Access Compliance Report

Public Rights-of-Way

Intersection ID: 29247	Main Street: CASTELLO_LN	Cross Street: MALLARD_FOREST_DR	Location: SW
ADA ID: 777AAD877417	Ramp Type: PerpDiag	Initial Pass/Fail: Fail	Overall Compliance: No
		Severity Score: 8.75

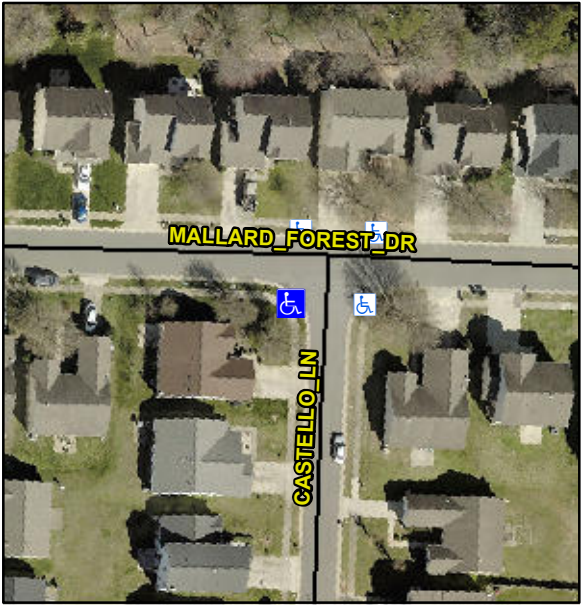
Codes/Mitigation Info/Possible Solution			Field Measurements/Component Compliance		
	Possible Solutions:		Compliance	Description	Data
	Remove & Replace Curb Ramp With Two New Directional Ramps or Equivalent.		Yes	Ramp Length (in)	6.4
			No	Ramp Width (in)	1.0
			N/A	Flare Type LT	N/A
			N/A	Flare Slope LT (%)	N/A
			N/A	Flare Traversable LT?	N/A
			N/A	Landing Length (in)	N/A
			N/A	Landing Width (in)	N/A
			N/A	Landing Slope (%)	N/A
			N/A	Landing X Slope (%)	N/A
<p>Surveyor Notes:</p> <p>N/A</p> <p>PROW/ADA:</p> <p>R304.5.1</p>			N/A	Flare Type RT	N/A
			N/A	Flare Slope RT (%)	N/A
			N/A	Flare Traversable RT?	N/A
			N/A	DWS Provided?	N/A
			N/A	DWS Contrast?	N/A
			N/A	DWS Length (in)	N/A
			N/A	DWS Full Width?	N/A
			N/A	DWS Offset (in)	N/A
			N/A	Gutter Ponding?	N/A
			N/A	Gutter Lip Ht (in)	N/A
			No	Painted X Walk1?	No
				X Walk 1 Direction	To E
			N/A	X Walk 1 Width (in)	N/A

2.8	X Walk 1 Slope (%)	2.3
			3.7	X Walk 1 X Slope (%)	2.0
			N/A	Ramp inside XWalk1?	N/A
			0.0	Road Slope (%)	N/A
			6.0	Road X Slope (%)	N/A
			N/A	Any Obstructions?	N/A
				Obstruction Type	
Total Cost:		\$ 3200.00	N/A	Storm Grate/Utility Hazard?	N/A
			N/A	Storm Grate/Utility Type	
			Yes	Surface Condition? (G/P)	Good
